DETAILS

A6.1.1

10 A2 - WINDOW SILL @ BEDROOM
3' = 1'-0"

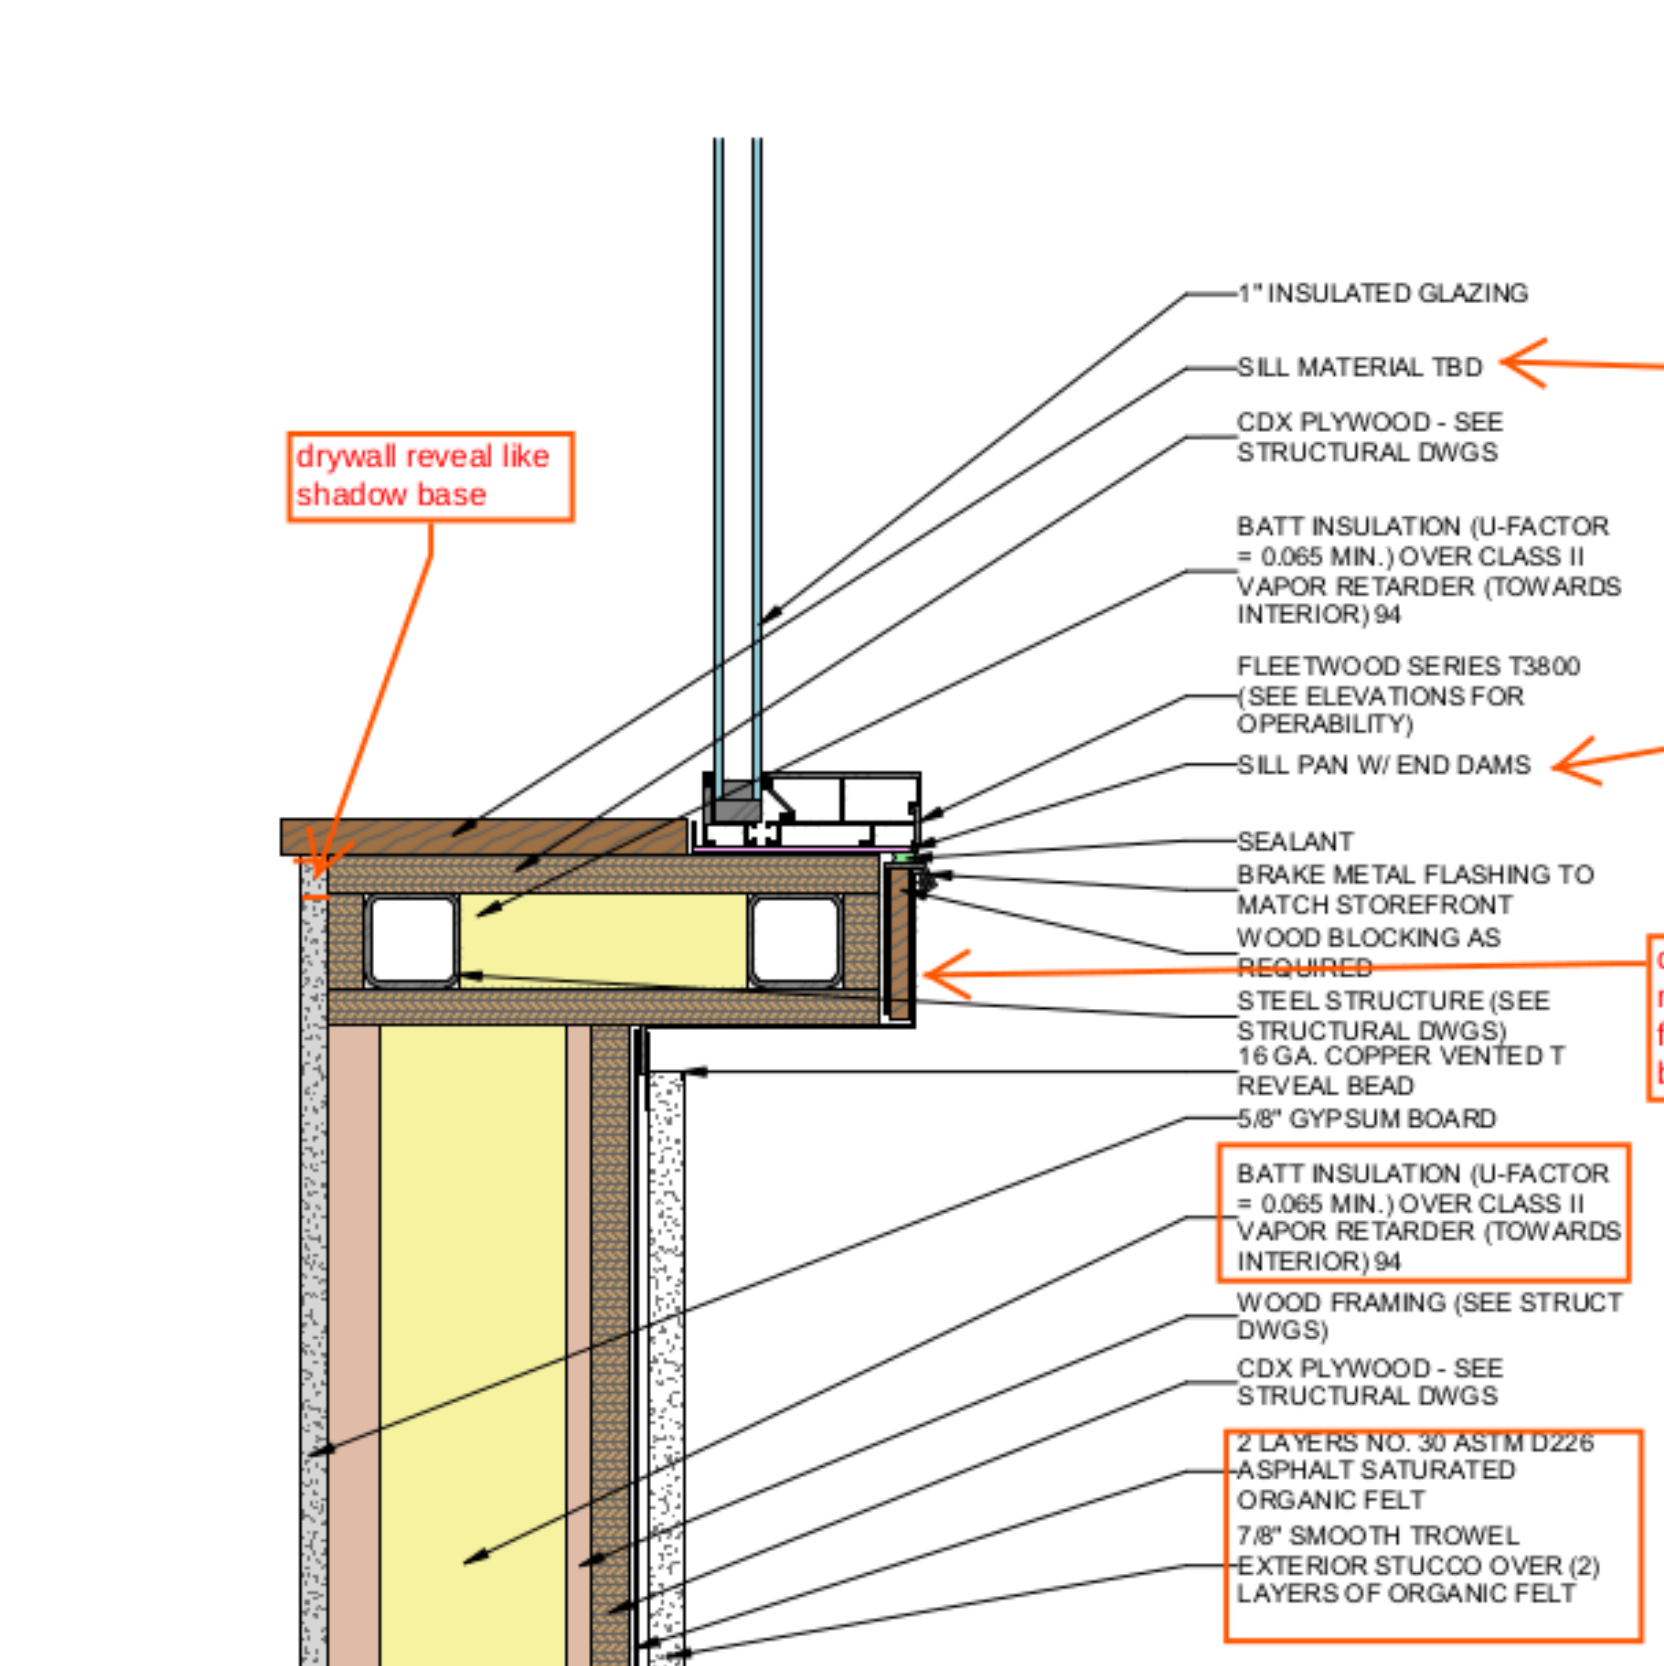
NO.	DESCRIPTION	DATE
1	add or note standard copper sill pan @ all exterior doors and windows, per detail 1/A4.1	
2	replace/ or add 2 layers of bituthane/ grace ice and water shield	
3	grade D building paper	
4	R value
